YUCCA MOUNTAIN PROJECT

REVIEW RECORD MEMORANDUM

EXPLORATORY SHAFT FACILITY (ESF) TITLE I DESIGN ACCEPTABILITY ANALYSIS AND COMPARATIVE EVALUATION OF ALTERNATIVE ESF LOCATIONS

VOLUME 3

FIGURE 24. MODIFIED PERMEABILITY ZONE MODEL FOR TOPOPAH SPRING WELDED TUFF FOR EXPECTED CONDITIONS AT 310 m DEPTH

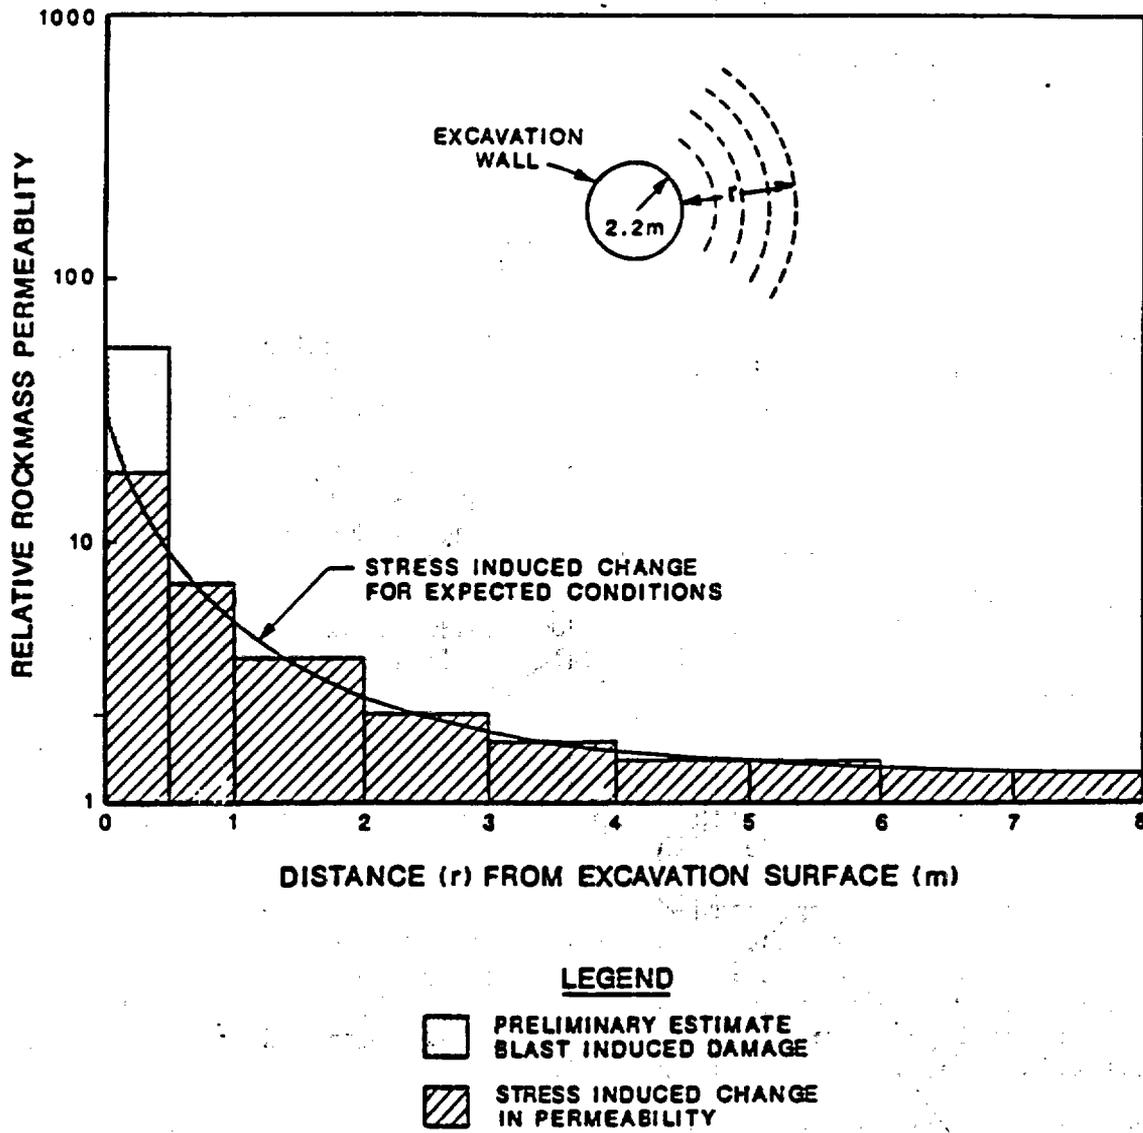
Figure 24 of Case and Kelsall (1987), which is attached, shows the relationship between relative rock mass permeability and distance from the shaft wall, due to blasting and stress induced changes for expected conditions at 310 m depth in the Topopah Spring welded tuff. For the annulus within 0.5 m of the shaft wall the permeability of the rock mass is expected to increase by a

FIGURE 24. MODIFIED PERMEABILITY ZONE MODEL FOR TOPOPAH SPRING WELDED TUFF FOR EXPECTED CONDITIONS AT 310 m DEPTH

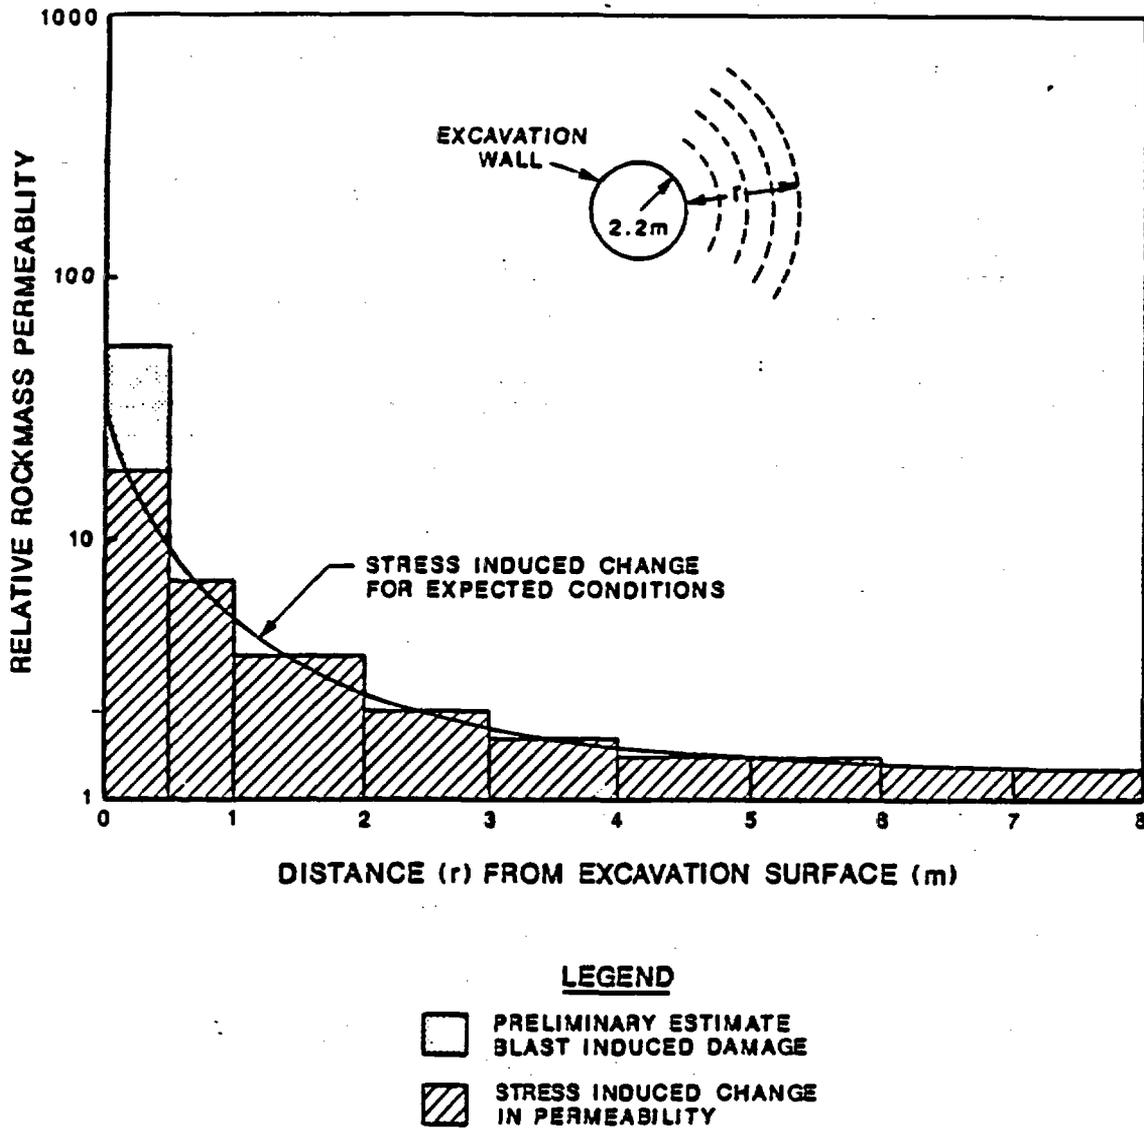
Figure 24 of Case and Kelsall (1987), which is attached, shows the relationship between relative rock mass permeability and distance from the shaft wall, due to blasting and stress induced changes for expected conditions at 310 m depth in the Topopah Spring welded tuff. For the annulus within 0.5 m of the shaft wall the permeability of the rock mass is expected to increase by a
